Proposed Revisions to a Standard Plans Index

Originator:	Turley, Joshua	Index Number:	102-201
Date:	6/27/2024	Sheet Number(s):	2
E-mail:	Joshua.Turley@dot.state.fl.us	Index Title:	TEMPORARY ACROW SERIES 700XS DETOUR BRIDGE BEAM AND GUARDRAIL DETAIL

THRIE BEAM TO BRIDGE GUARDRAIL TRANSITION

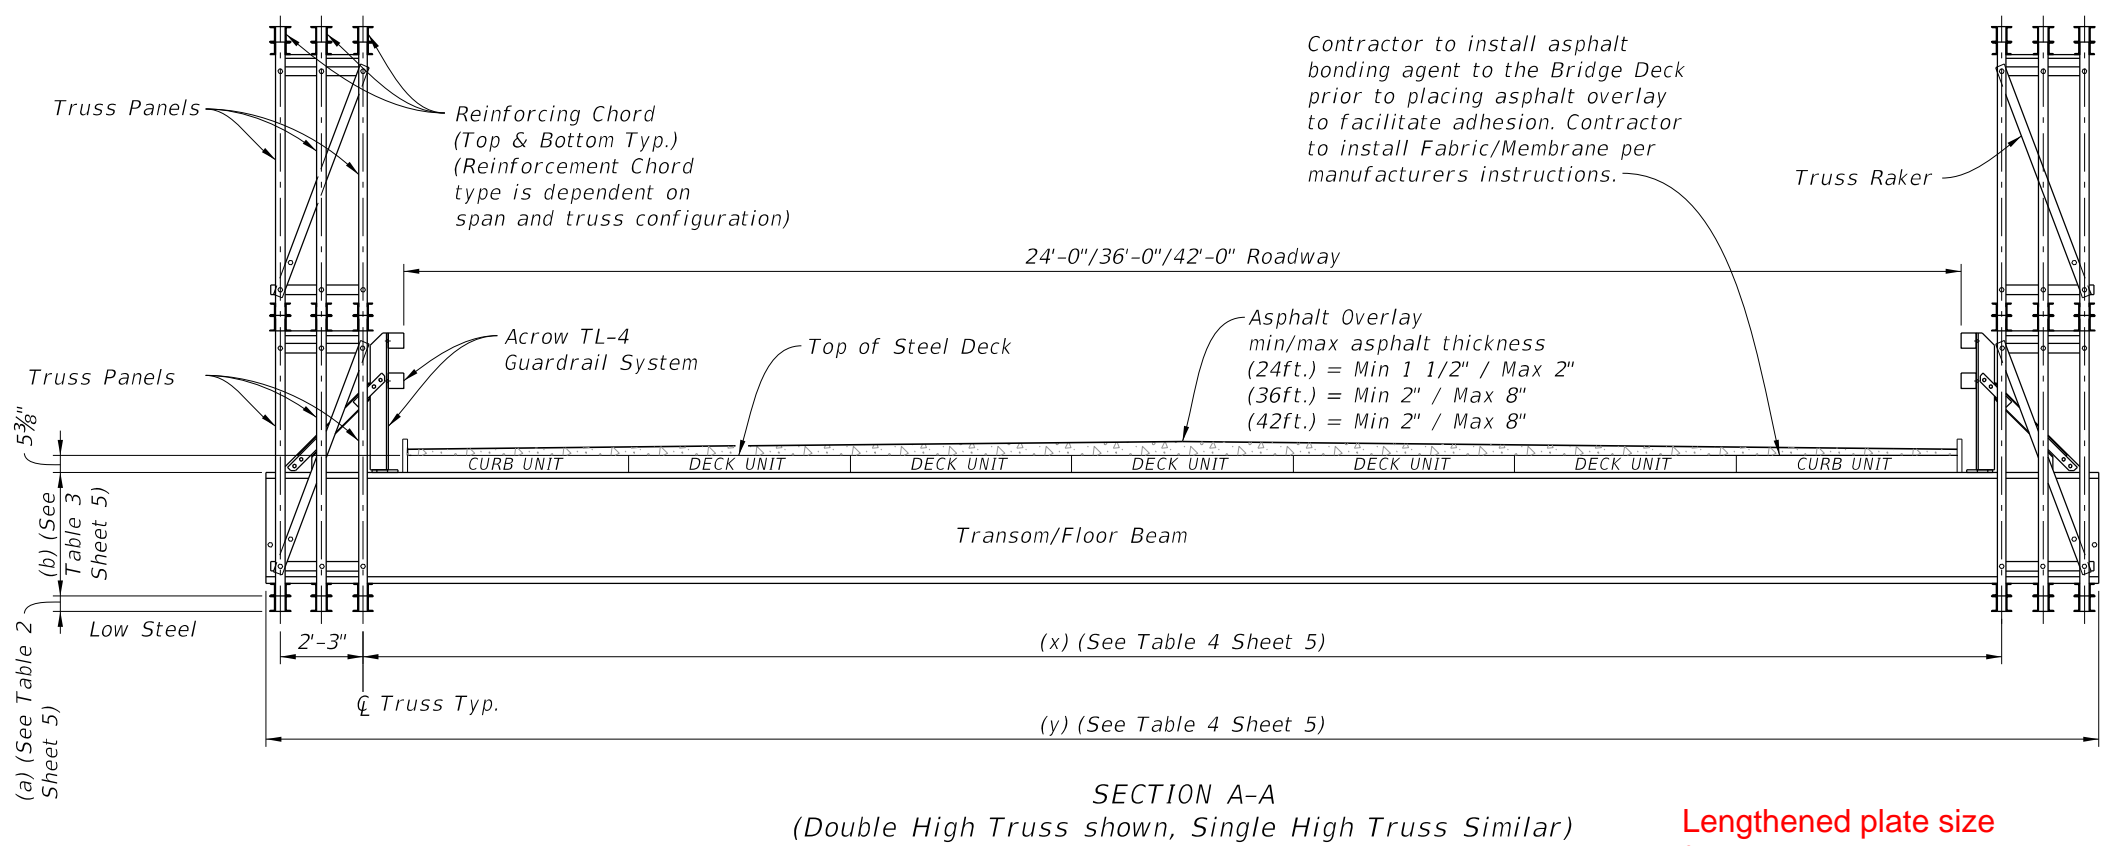
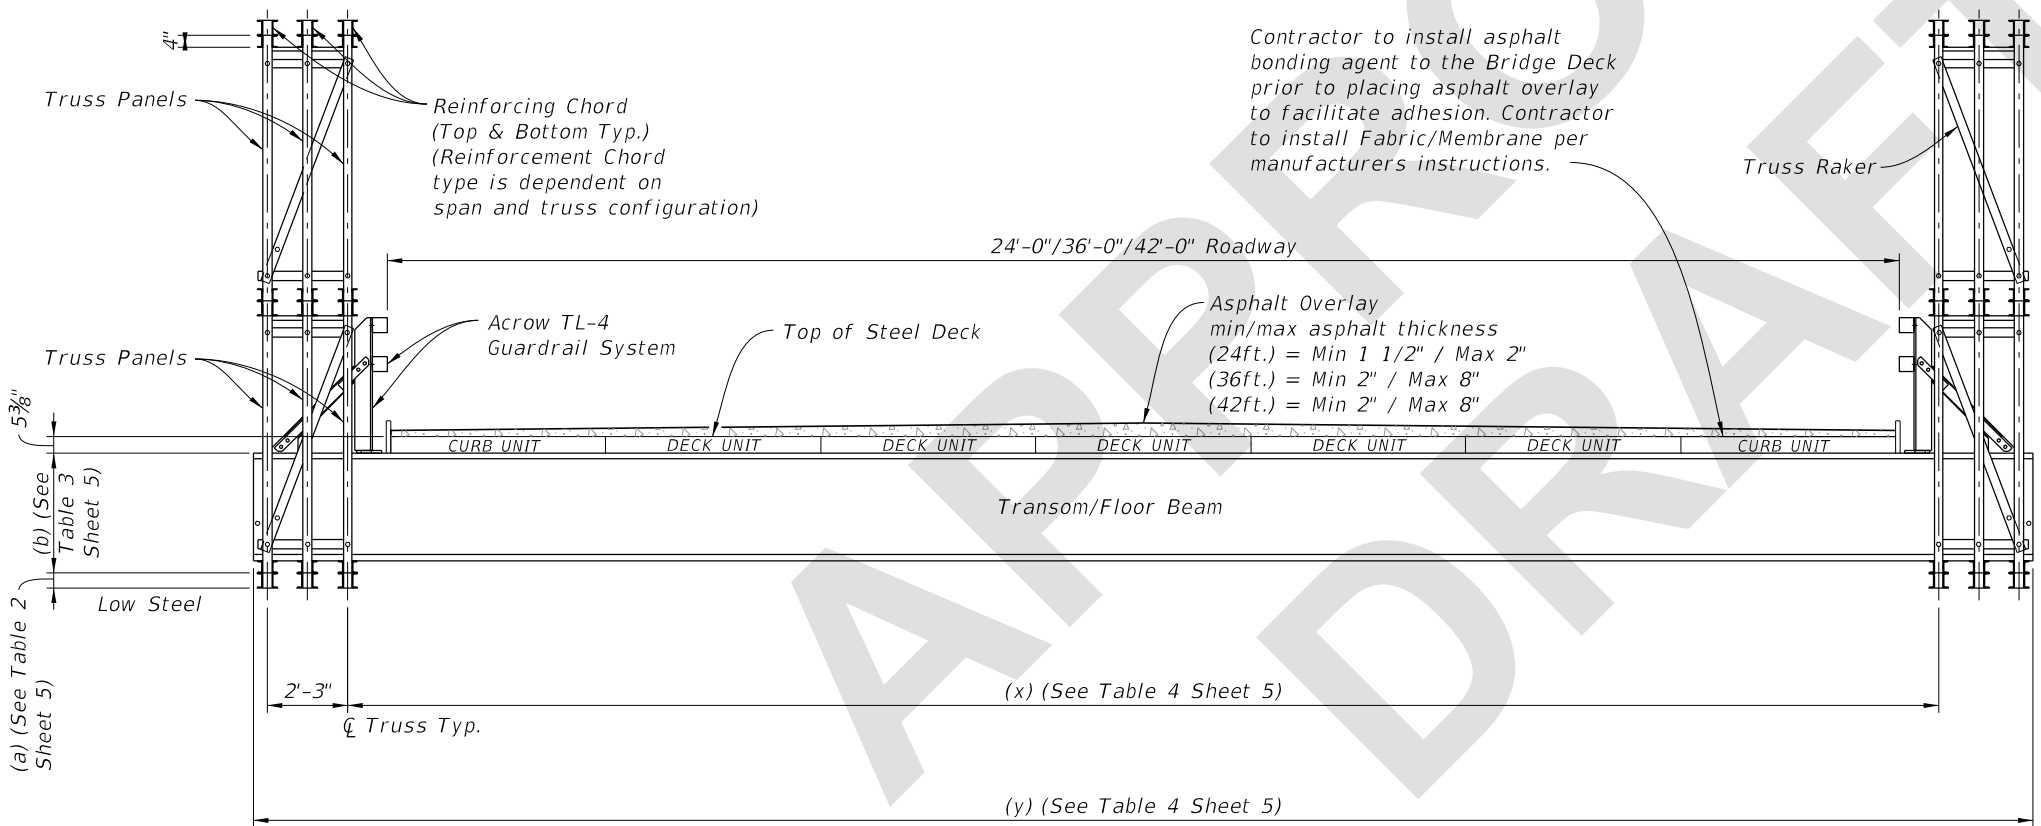
Sheet 2: Added Paved Surface to Thrie Beam to Bridge Guardrail Transition detail and updated dimensions to accommodate; Added additional callouts to Guardrail End Transition detail; Lengthened the plate size in the 1/4" Guardrail Back Plate Detail, clarified the dimensions and added notes

UPDATED dimensions and detail to accommodate paved surface

1/4" GUARDRAIL BACK PLATE DETAIL

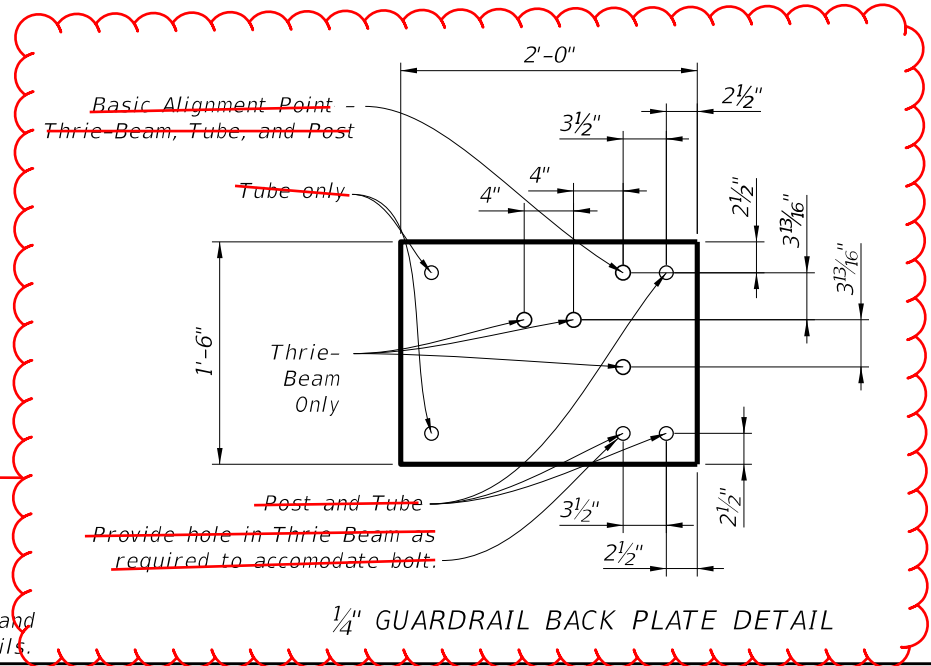
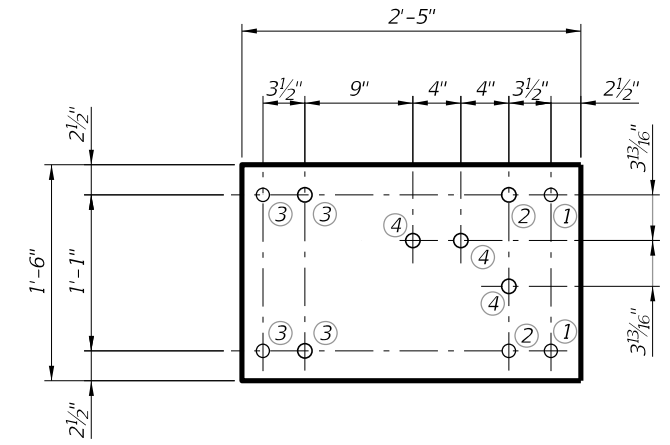
Lengthened plate size for better alignment and added notes for clarity

Back Plate is ASTM A36.
Use plate washers for all Thrie-Beam to plate connections.
Use 7/8" Ø Hex Head Bolts.
Drill, ream, or slot holes in Thrie-Beam connector as required for fit up.
